FIELD OBSERVATION – FIFTH FLOOR WEST IN-WALL AND CEILING MECHANICAL, PLUMBING AND SPRINKLER REPORT 09-13-2016

AEI Project Number and Name: 14018 – The Park Danforth

Unit 1501

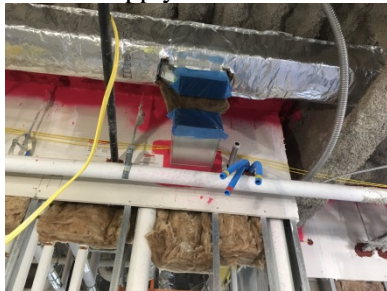
- Supply duct elbow missing.
